Subject: **Declaration Letter about Identity of Products**

Product Description	Golf Trolley
Model No.	AI NAVIGATOR HALO
Manufacturer's Name	MGI Golf Inc
Manufacturer's Address	6825 Speedway Blvd Suite #B101B Las Vegas, NEVADA 89115

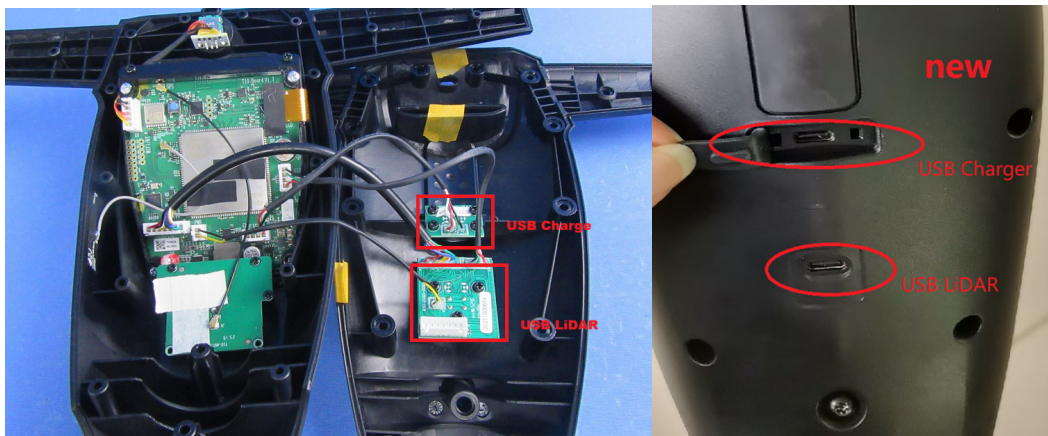
1. New model (AI NAVIGATOR HALO) add A new USB-C interface board has been added for the LiDAR connection, and add a new USB-C board has been added for the charging port.
(refer to the photos below)

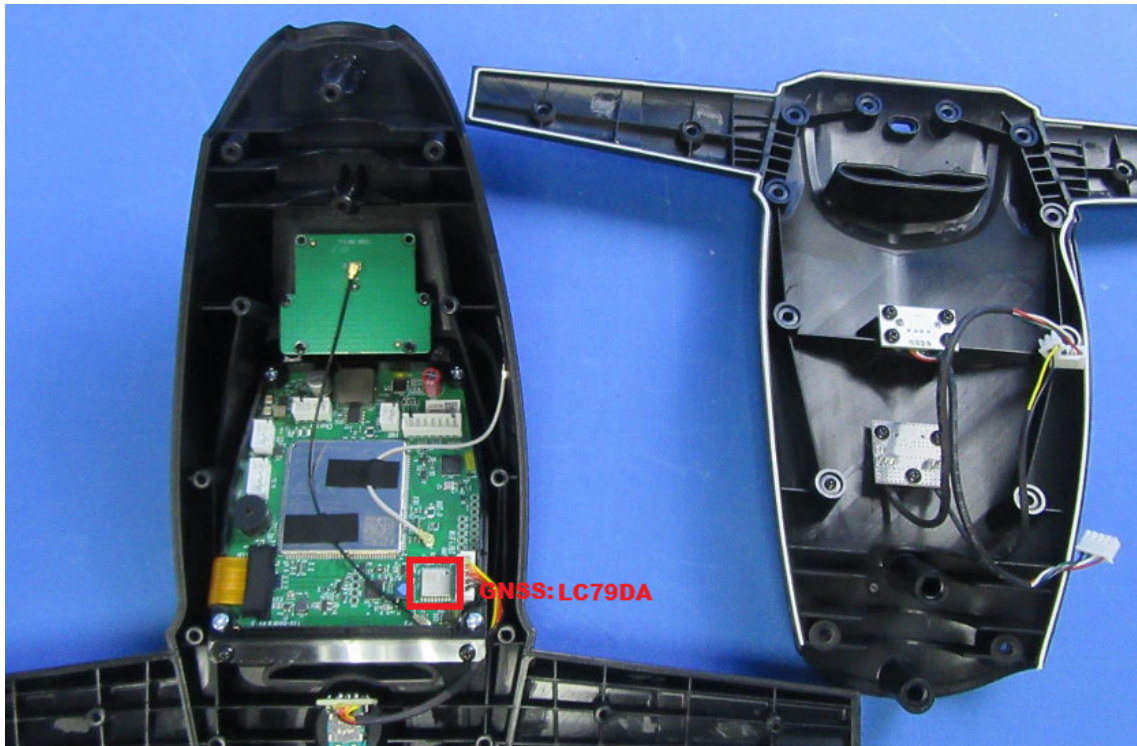
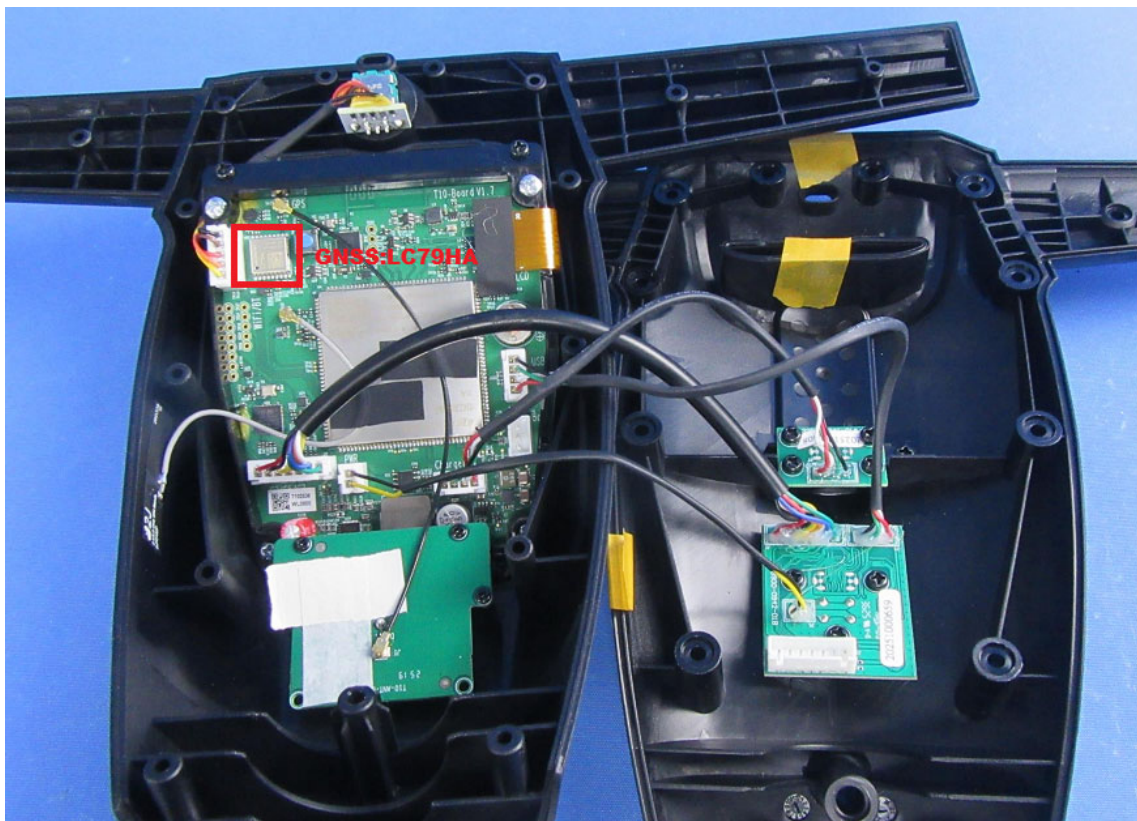
2. The main PCB version from V1.3 changed to V1.7, only updated the GNSS module from LC79DA to LC79HA. (refer to the photos below)
